Prairieville Township T 1 N R 10 W Barry County Michigan

Section 12 08-12-012- Scale 1"= 400'

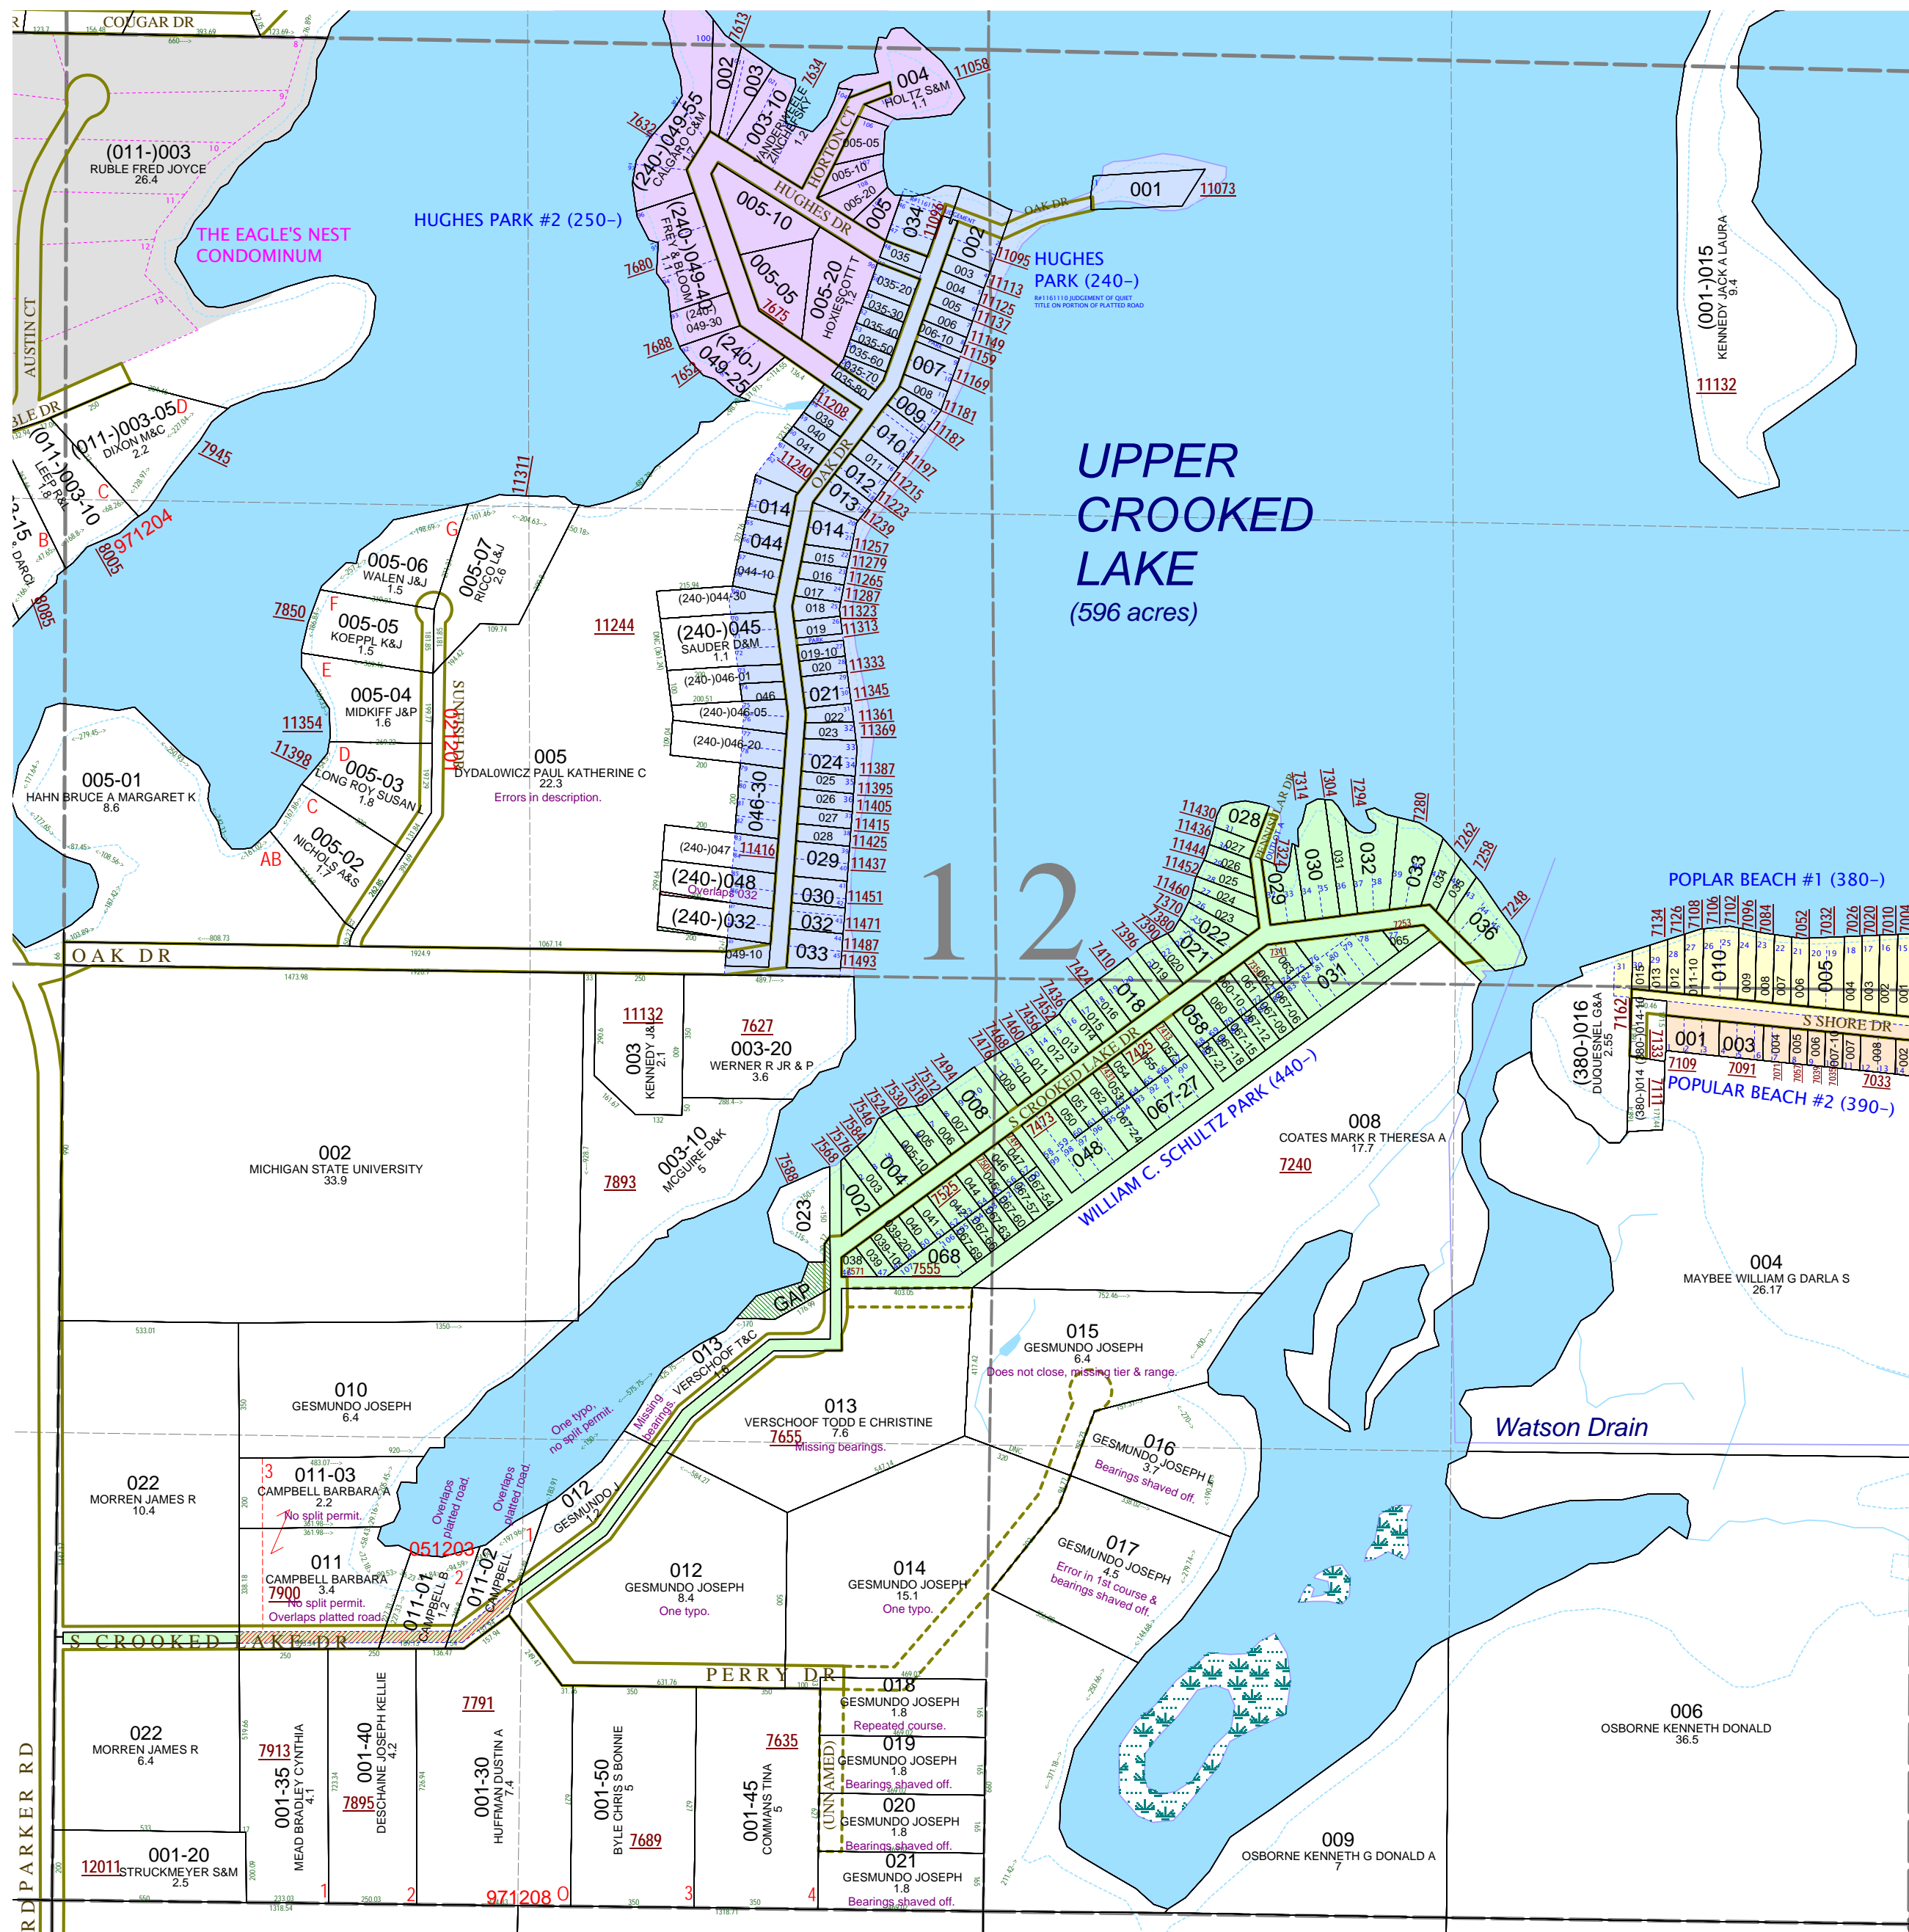
08-12-012-005-00 has a "zero" in the name field, does not close, has extra courses and is mixing measurements and bearings from two different surveys. They also messed up the lot extensions down by lots 87&88 creating a wedge overlap.

08-12-240-048-00 overlaps 032-00 because in change in how the lots were described between deeds. It should exclude parcel deeded previously to Phillips until a corrective survey description can be made.

GAP north of parcel 013-00 owned by Gesmundo.

08-12-012-013-00 is missing the seconds off the course bearings. Correction reads from deed L.590-727.

08-12-012-011-00 should not include platted road in William C. Shultz Park.

08-12-012-011-01 should not include platted road in William C. Shultz Park.

08-12-012-011-02 should not include platted road in William C. Shultz Park.

08-12-012-012-00 has one small typo, change "89D 45M 30S E, 1169.47 FT" to "N89°45'30"E 1169.47FT"

08-12-012-018-00 has a repeated course to its point of beginning.

08-12-012-019-00 has had its course bearings shaved off.

08-12-012-020-00 has had its course bearings shaved off.

08-12-012-021-00 has had its course bearings shaved off.

08-12-012-015-00 does not close, is missing tier & range and the seconds off the course bearings. We don't have a survey to totally reconstruct the missing parts

08-12-012-016-00 has had its bearings shaved off and should read as deeded in L.632-748.

08-12-012-017-00 has an error in first course and has had its bearings shaved off but I don't have the survey to totally reconstruct the missing parts.

08-12-012-014-00 has one small typo, change "TH 89D 45M 30S E, 1169.47 FT" to "TH N89°45'30"E 1169.47FT"
